YARRA PLANNING SCHEME

SCHEDULE 18 TO CLAUSE 43.02 DESIGN AND DEVELOPMENT OVERLAY

Proposed C273yara

HEIDELBERG ROAD PRECINCTS

Figure 1: Indicative Cross Section and Measurements

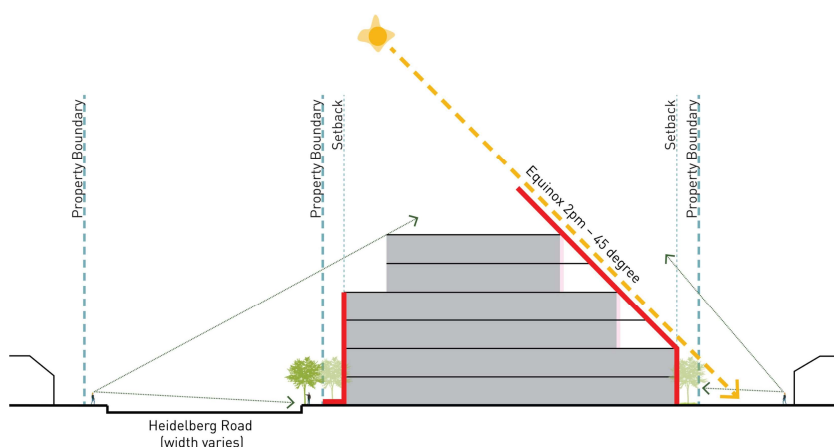
Development must provide minimum ~~landscape-ground floor~~ setbacks to the rear boundary as follows:

- Precinct 1: ~~a minimum of~~ 3 metres (as shown on Map 1);
- Precinct 3A: ~~a minimum of~~ 4.5 metres;
- ~~Precinct 2 and Precinct 3B: All other areas: a minimum of 3 metres if the dwelling on the adjacent residential property is located less than 15 metres from the property boundary:~~
 - ~~5 metres where a development site directly abuts a rear boundary of an adjacent residential lot.~~
 - ~~3 metres where a development site directly abuts a side boundary of an adjacent residential lot.~~

Commented [YCC6]: In response to Submission 5, 34, 54 and 117 regarding improving the rear interface controls.

Map 1: Building and Street Wall Heights for Precinct 1

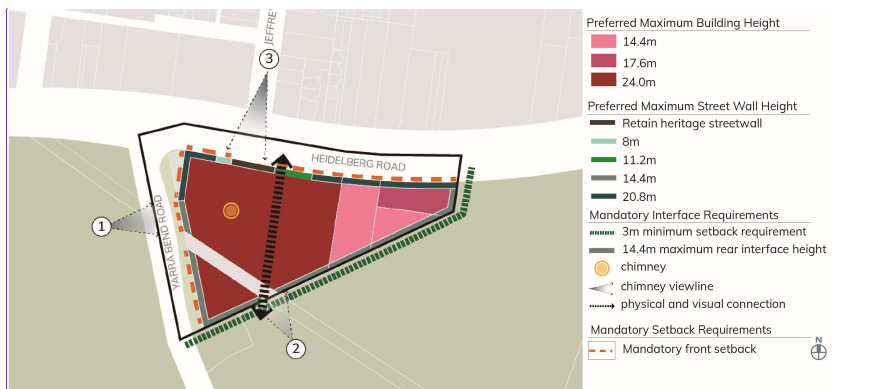
Commented [YCC17]: Officer additions to provide more clarity around the location of the chimney which has been added onto Map 1.
